ADDENDUM NO. 30 - Contract Drawing C.1

**CONTRACT 876-HP
GEOMEMBRANE CAPPING AND
GAS COLLECTION SYSTEM
PELHAM BAY LANDFILL REMEDIATION
BOROUGH OF THE BRONX
NEW YORK**

Bid Form - Contract No. 876-HP - Revised 5/25/94

REVISED SECTION B			
CONTRACT DRAWING C.12			
PELHAM BAY LANDFILL, BRONX, NEW YORK			
WOODWARD-CLYDE CONSULTANTS, INC.			
ENGINEERING & SCIENCES APPLIED TO THE EARTH & ITS ENVIRONMENT			
NEW YORK, NEW YORK			
DR. BY	WVB	SCALE 1/2" = 1'-0"	DWG. NO. 24087032
CK'D. BY	MTZ	DATE	JUNE 10, 1994
		FIG. NO.

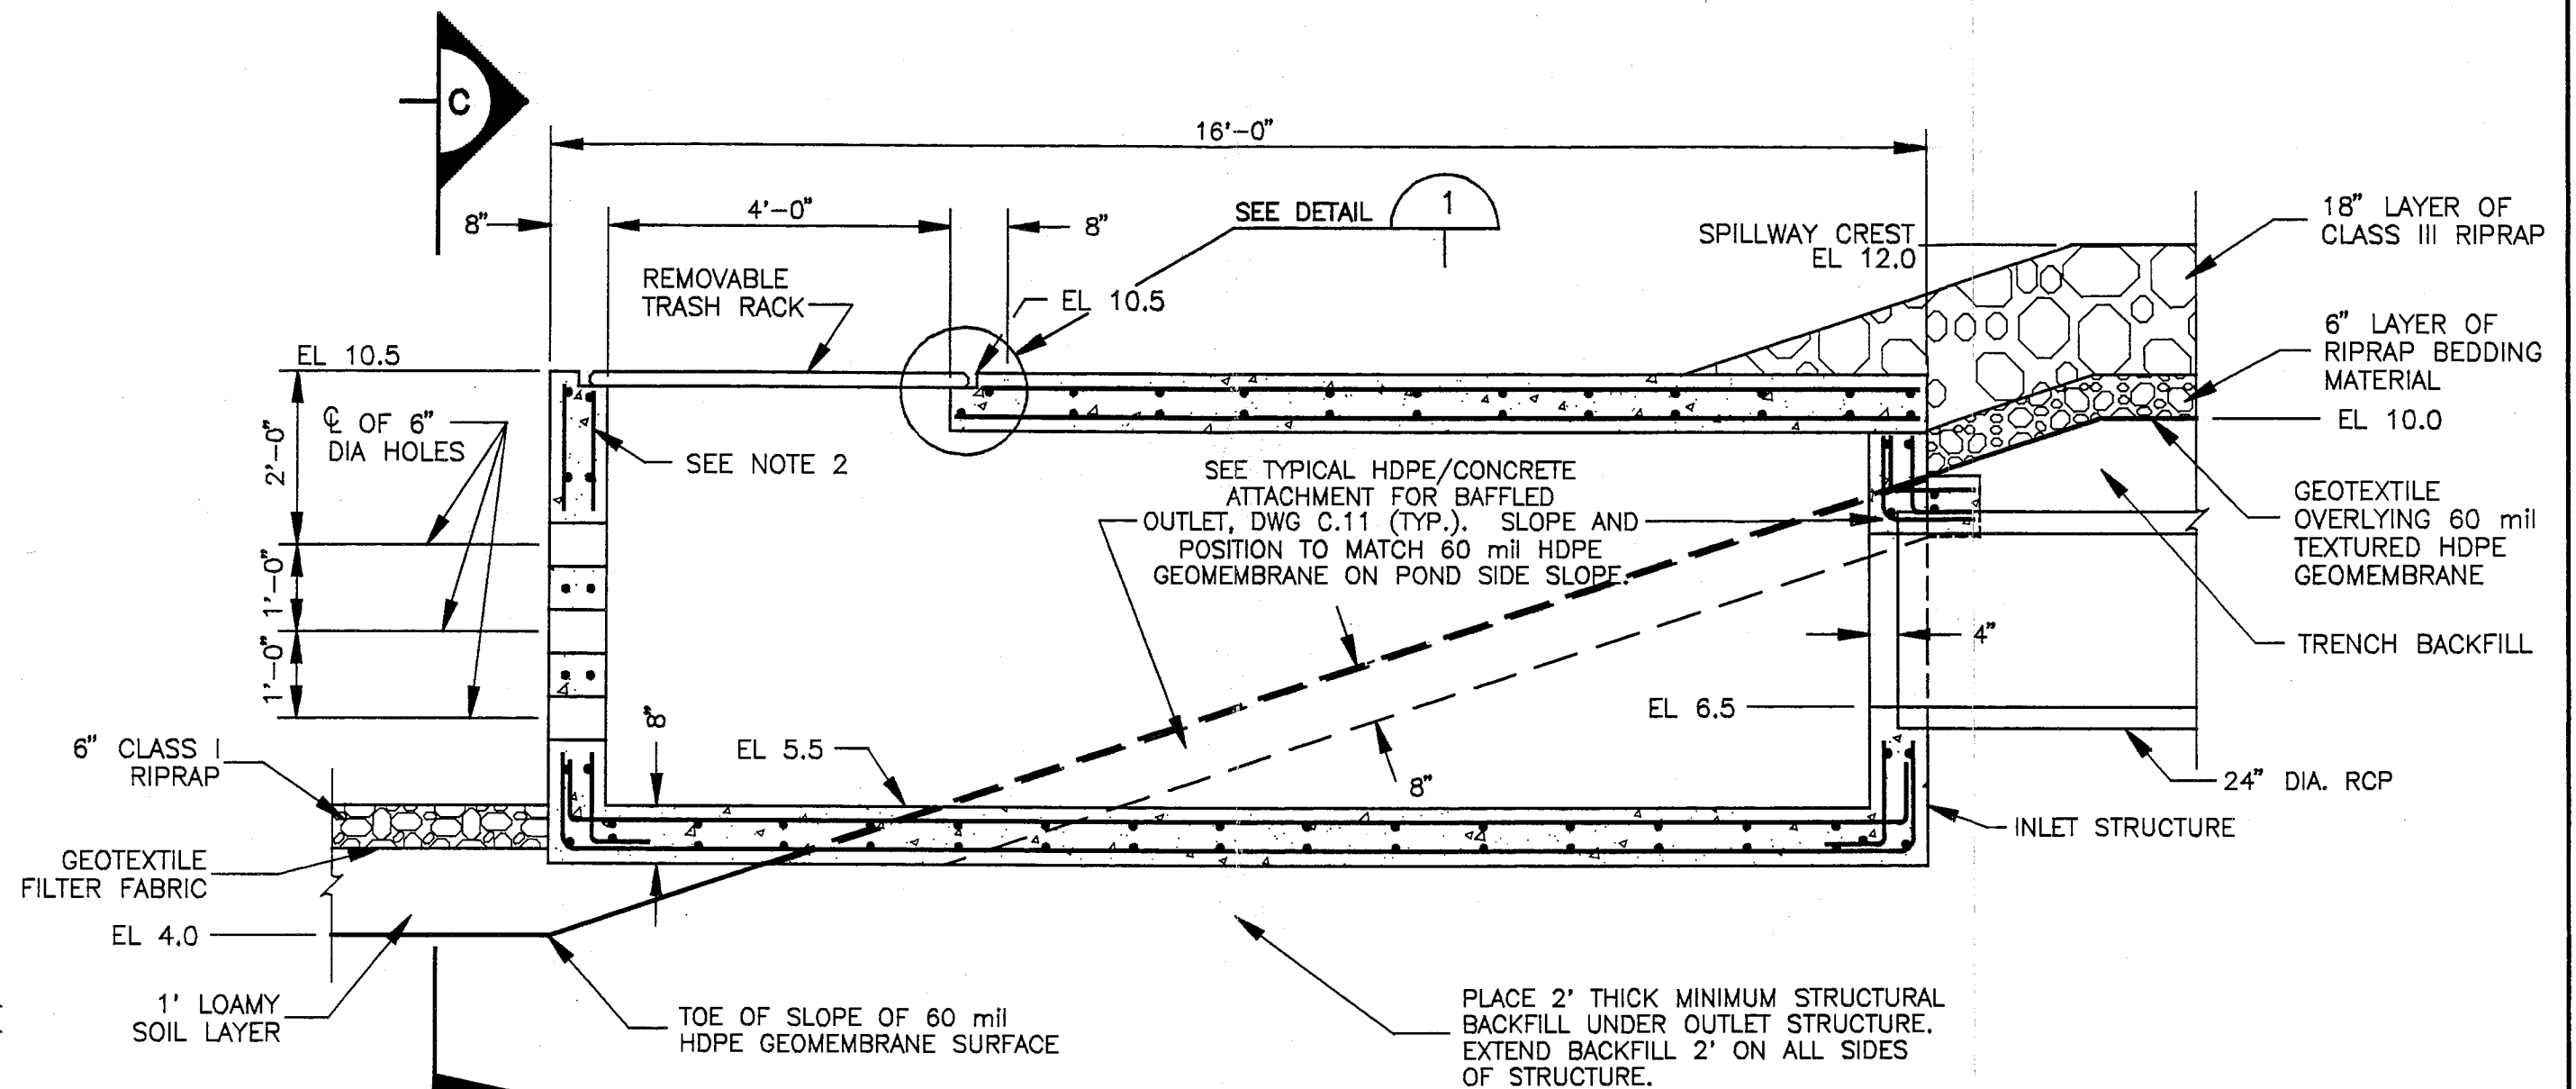
1. Delete "INLET PLAN POND C PIPE OUTLET- SECTION A" and replace with revised version, attached on the following pages.
2. Delete "INLET SECTION POND C PIPE OUTLET- SECTION B" and replace with revised version, attached on the following pages.
3. Delete "ELEVATION- SECTION C" and replace with revised version, attached on the following pages.
4. Delete "SEAT DETAIL 1" and replace with revised version, attached on the following pages.
